**TOWN OF CARMEL  
PLANNING BOARD**

**PLANNING BOARD AGENDA**  
**JULY 17, 2019 – 7:00 P.M.**

RE: Amended Site Plan for Downtown Mahopac Properties, Inc.  
559 Route 6  
Mahopac, NY 10541  
TM # 75.12-2-26

**SITE PLAN**

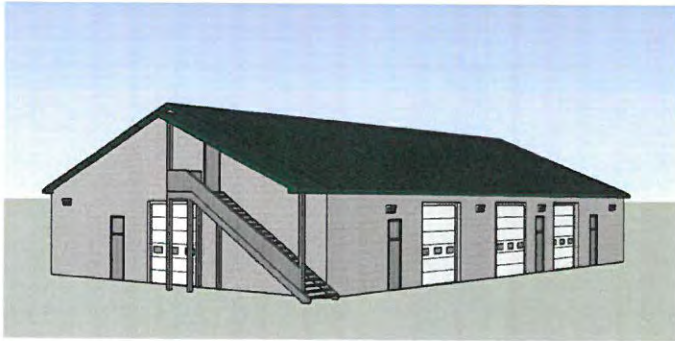
The following is my response to the memo from Mike Carnazza, Building Inspector dated June 25<sup>th</sup>, 2019:

1. The lot depth line is now shown at the mid-point.
2. Set back envelope is indicated.
3. The frame shed it noted to be removed.

The following is my response to the memo from Pat Cleary, Town Planner dated June 26<sup>th</sup>, 2019:

1. The use of the warehouse has been clarified. Its' use is not related to the other businesses on the site.
2. The parking table identifies the parking requirements for the 2 existing buildings.
3. The parking spaces are shown at 10 ft wide.
4. The Putnam Trailway is not an abutting property.
5. We will contact NYSDOT regarding the planting of grass along Rt 6.
6. Illumination levels are identified;
7. Renderings of the proposed building with materials and colors identified.
8. The existing asphalt parking area will be resurfaced.
9. A stormwater management report is attached.

**PARKING SITE PLAN**  
GRAPHIC SCALE  
1" = 40'

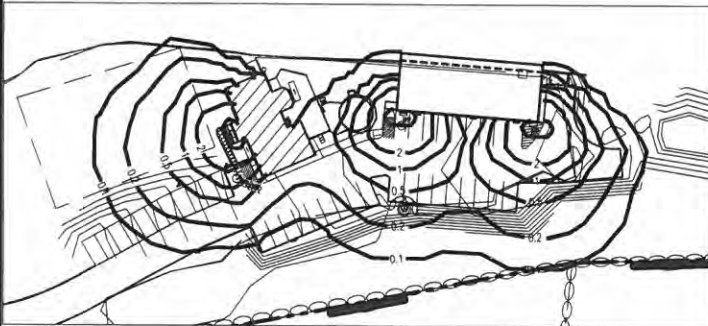
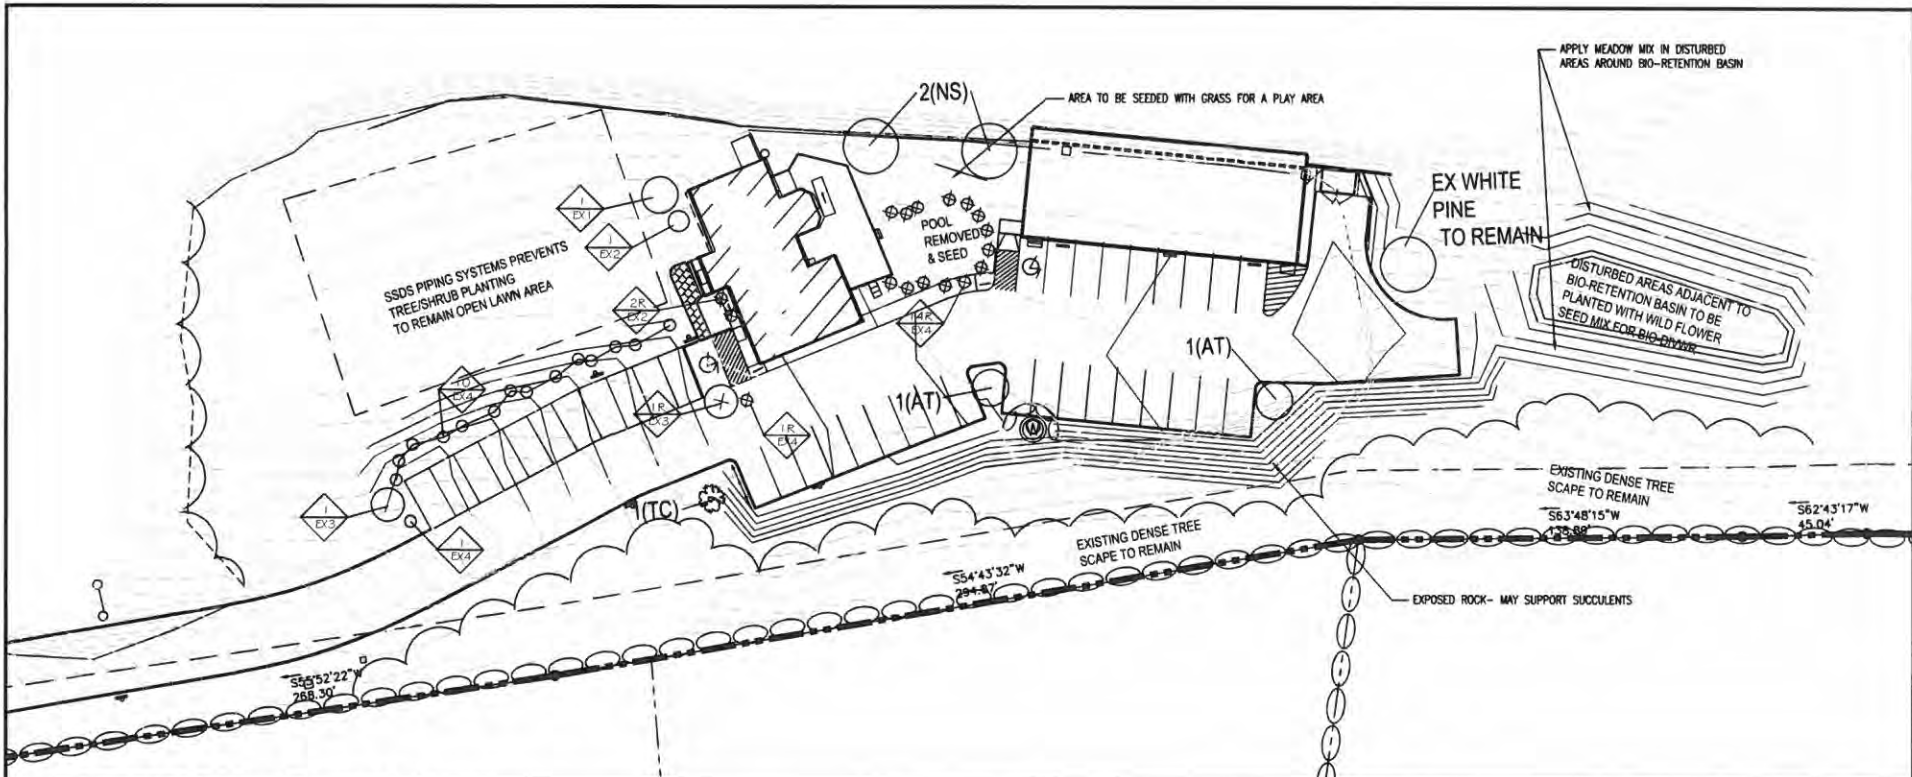
11 Added to the west of the driveway (1 extra to compensate for H/C space)

**STORM WATER MANAGEMENT SITE PLAN**

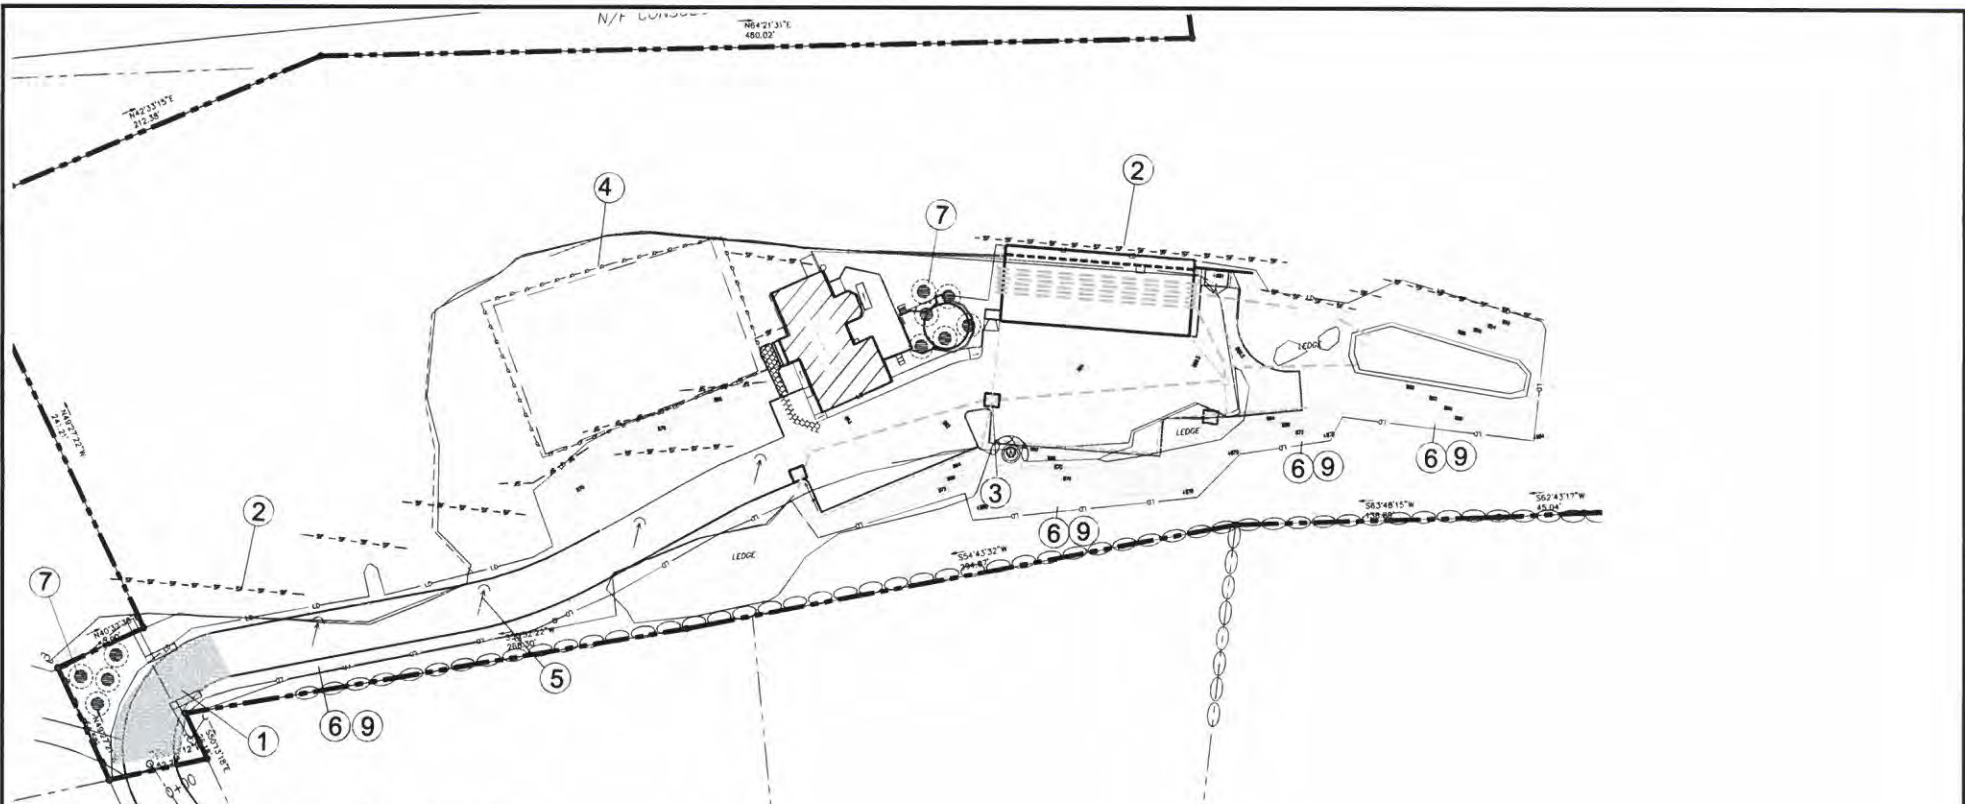
1. a. The plan has been submitted to the Mahopac Falls Fire Department. A response is pending. The site plan is in conformance with the NY State Fire Code for the hammerhead turn around.
2. a. Permits – Acknowledge NYSDEC GP-0-15-002 construction activity.
3. The SWPPP has been provided for review.
4. The Performance Bond shall be estimated once SEQRA Review is complete for the project.
